WOLF CREEK

December 14, 2007
ET 07-0062

Subject: Docket No. 50-482: Response to Request for Additional Information Relating to Replacement of the Main Steam and Feedwater Isolation Valves and Controls

RESPONSE TO NRC REQUEST FOR ADDITIONAL INFORMATION

FIGURE 1

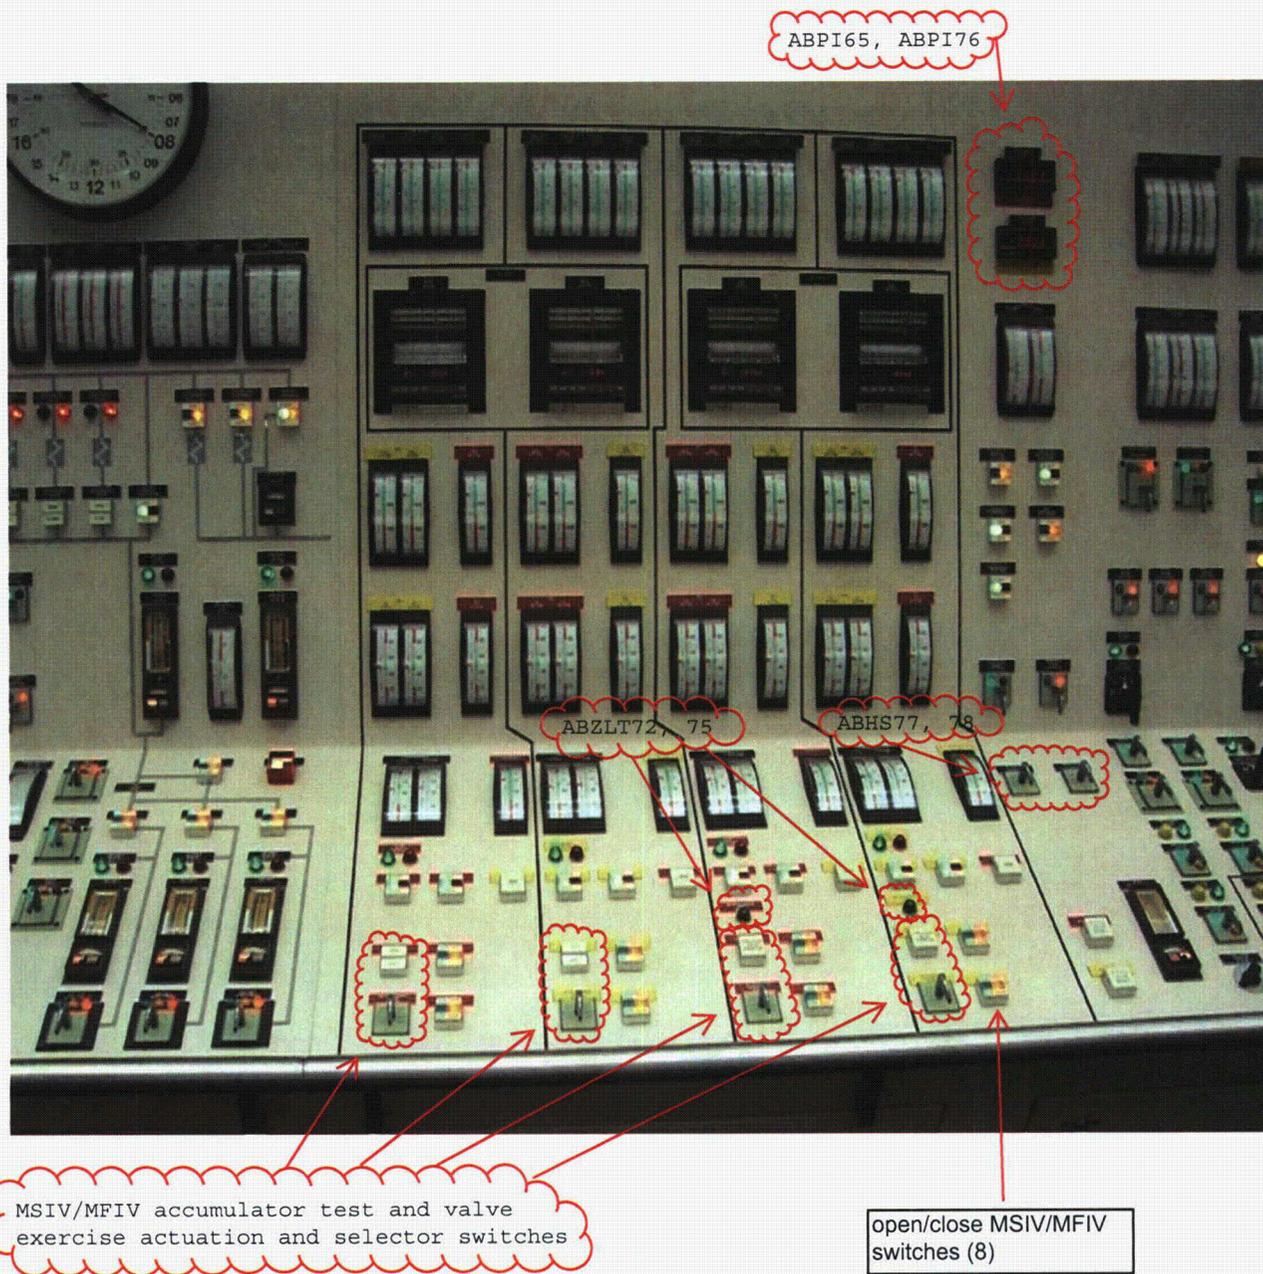
1. *This LAR proposes to incorporate changes to TS 3.3.2, "Engineered Safety Feature Actuation System (ESFAS) Instrumentation," based on a planned modification to replace the MSIVs and associated actuators, MFIVs and associated actuators, and replacement of the Main Steam and Feedwater Isolation System (MSFIS) controls. Identify and describe any changes or additions to human interfaces for control room controls, displays, and alarms that could affect the operator's ability to interpret, read or visually identify the information that they will require from the instrumentation.*

Response: As discussed in letter ET 07-0004, the MSIVs and MFIVs hydraulic actuators are being replaced with system-medium actuators. The existing Main Control Board (MCB) switches, displays, and alarms associated to the hydraulic actuators will be removed. Elimination of the hydraulic actuators will reduce the number of switches and indications that are required for maintaining the hydraulics for the MSIVs and MFIVs. Provided below is the instrumentation being removed from the MCB.

- Hydraulic pressure indicating instruments and selector switches: ABPI65, ABPI76, ABHS77, and ABHS78
- MSIV/MFIV Accumulator Test and Valve Exercise Actuation and Selector Switches: actuation switches ABHS66, ABHS68, ABHS70, and ABHS73 and selector switches ABHS67, ABHS69, ABHS71, and ABHS74
- MSIV/MFIV Exercise Position green indicating lights: ABZL72, belonging to Separation Group 1 and ABZL75 belonging to Separation Group 4

In Figure 1 (see page 7 of 8 of this Attachment), the instrumentation being removed is shown by "clouding."

The existing open/close switches that operate the individual valves remain the same, as well as the manual actuation switches, which close all four MSIVs or MFIVs valves simultaneously.
